Project	<b>IEEE 802.16 Broadband Wireless Access Working Group</b> < <a href="http://ieee802.org/16">http://ieee802.org/16</a> >
Title	<b>Correction of Ranging Primitive Example</b>
Date Submitted	<b>2006-11-16</b>
Source(s)	Jaesun Cha and Chulsik Yoon <a href="mailto:jscha@etri.re.kr">jscha@etri.re.kr</a> ETRI 161 Gajeong-dong, Yuseong-gu Daejeon 305-700 Korea
Re:	Contribution on comments to IEEE 802.16g/D5
Abstract	Correction of ranging primitive example
Purpose	Adoption
Notice	This document has been prepared to assist IEEE 802.16. It is offered as a basis for discussion and is not binding on the contributing individual(s) or organization(s). The material in this document is subject to change in form and content after further study. The contributor(s) reserve(s) the right to add, amend or withdraw material contained herein.
Release	The contributor grants a free, irrevocable license to the IEEE to incorporate text contained in this contribution, and any modifications thereof, in the creation of an IEEE Standards publication; to copyright in the IEEE's name any IEEE Standards publication even though it may include portions of this contribution; and at the IEEE's sole discretion to

Figure F9 – The use of Ranging Primitives

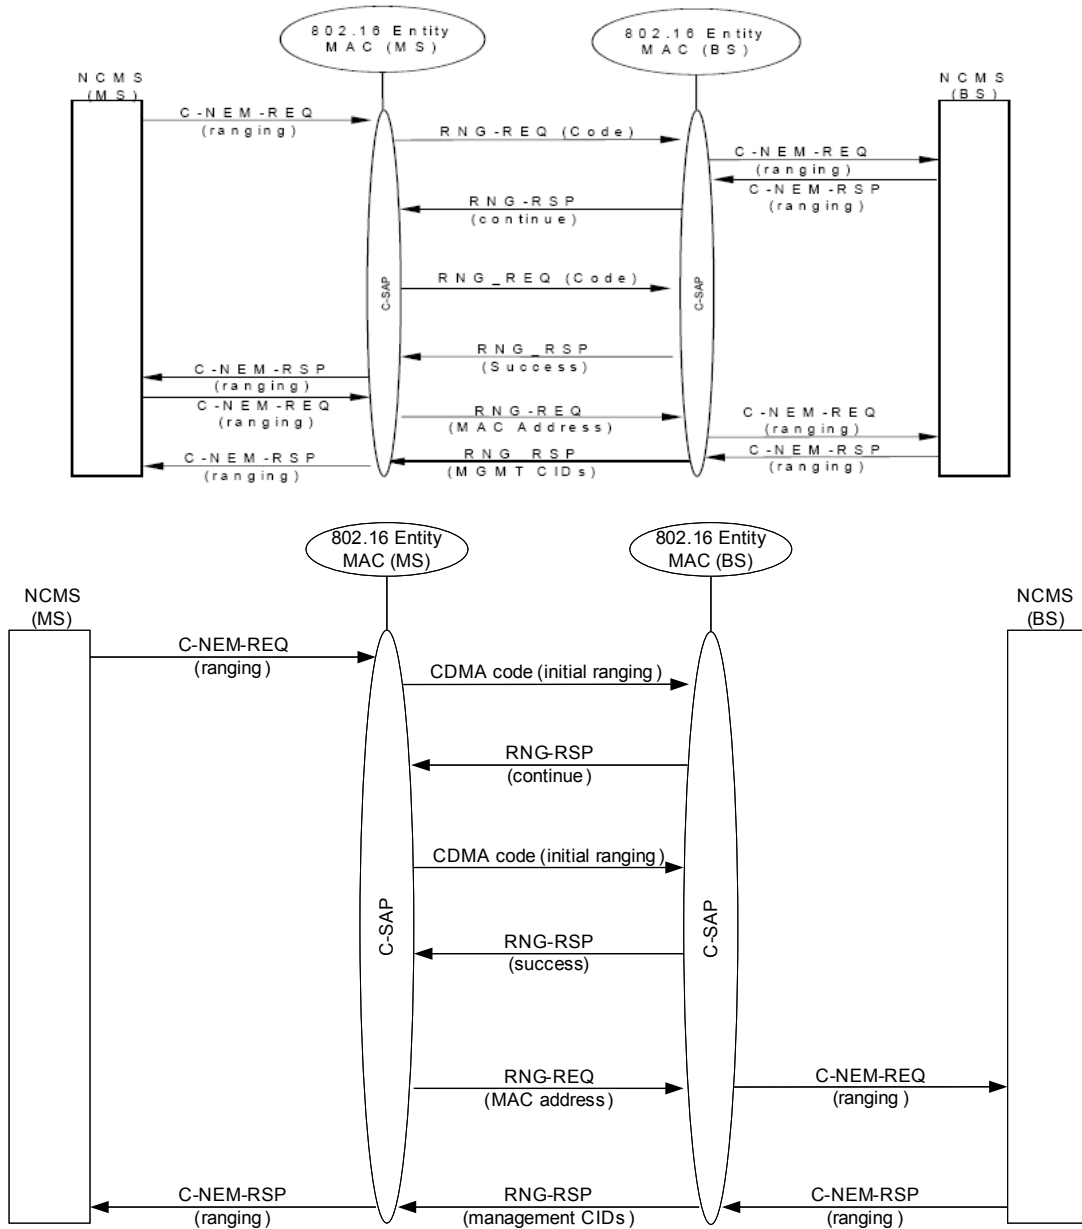
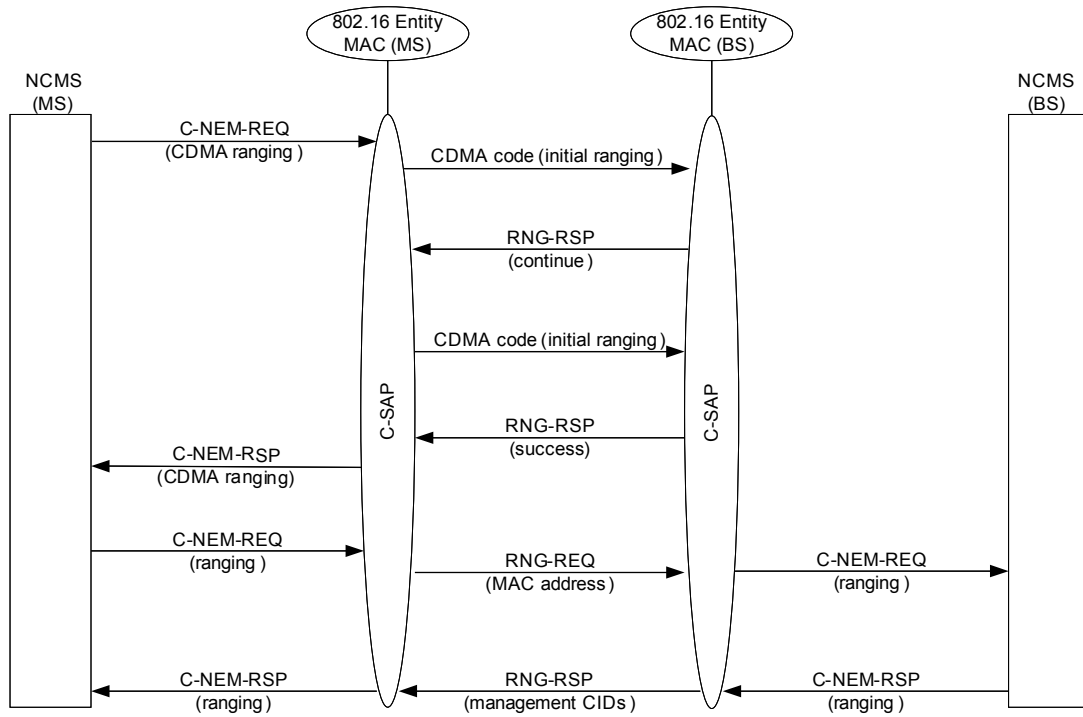
Figure F9 shows how ranging primitives can be used when 802.16 device performs initial ranging. According to the Figure, NCMS at MS and BS participates in code-based ranging as well as message-based ranging procedure.

Because NCMS is a high-level logical entity and code-based ranging is a pure MAC-layer function, it is not a good approach for NCMS to participate in code-based ranging procedure. Only thing that NCMS needs to do is to trigger code-based ranging procedure.

In addition, NCMS doesn't need to manage parameters included in RNG-RSP sent to MS as a response to CDMA code for initial ranging because only BS can manage those parameters (timing off adjustment, frequency adjustment, power level adjustment, etc) related with air interface.

Peretz's Comment: Suggest change to this Figure per the Figure below

*[Modify F.4 Ranging Primitives Usage as follow]*
